# TECHNICAL BULLETIN

## OIL COOLING INLET DUCT MODIFICATION

\* Supersedes Service Letter SL900-030, dated 11 April 1997.

**Figure 1. Oil Cooling Duct Access Holes**

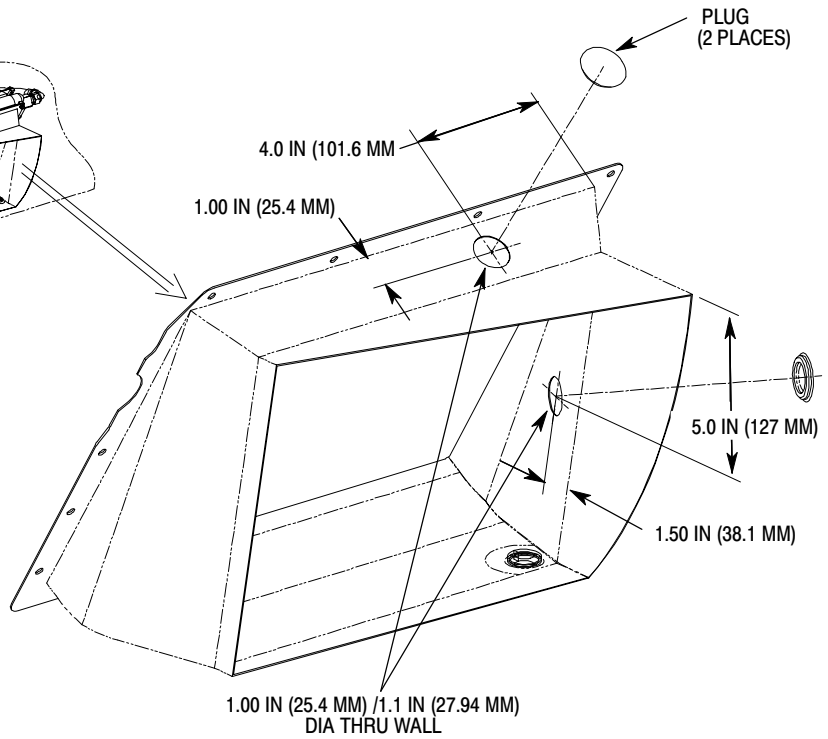
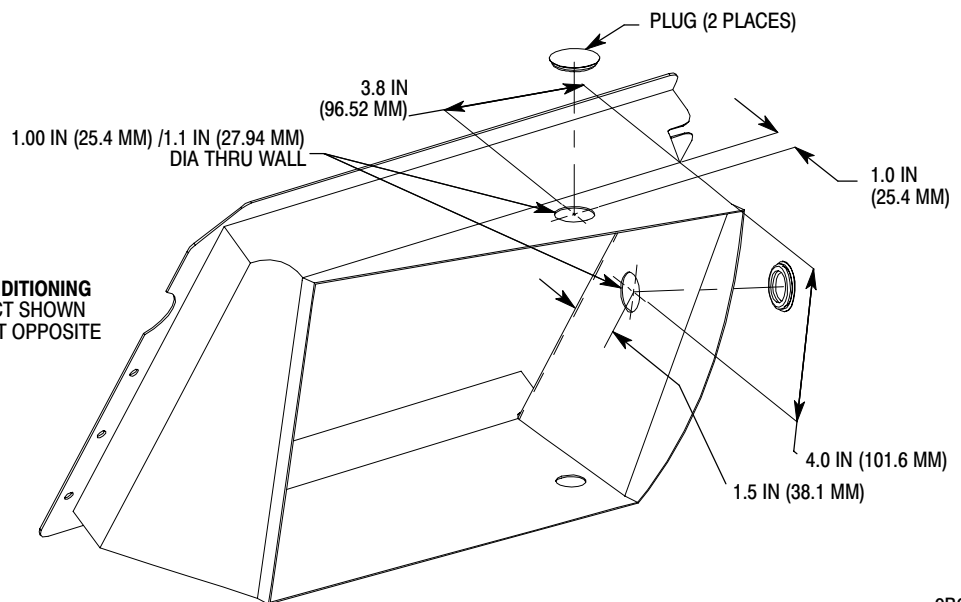
To allow operators to remove debris from in front of the heat exchanger or condenser without removing the cooling inlet ducts.

Procedures in this Bulletin provide owners and operators with information pertaining to adding access holes to the left and right side cooling inlet ducts.

- (1). Remove forward fairing support assemblies (Ref. CSP-900RMM-2, Section 53-30-00, Forward Fairing Support Assembly Removal).  
(Ref. Figure 1)
- (2). Support inboard wall of duct using wood at hole locations. Wood piece should be clamped firmly and be thick enough for adequate support.
- (3). Cut holes using 1.0 inch (25.4 mm) wood working hole saw.
- (4). Remove wood support and use #120 sandpaper to deburr holes. Using sandpaper, open holes as required to allow for plugs to fit.
- (5). Remove all debris and install plugs in holes.
- (6). Install forward fairing support assemblies (Ref. CSP-900RMM-2, Section 53-30-00, Forward Fairing Support Assembly Installation).
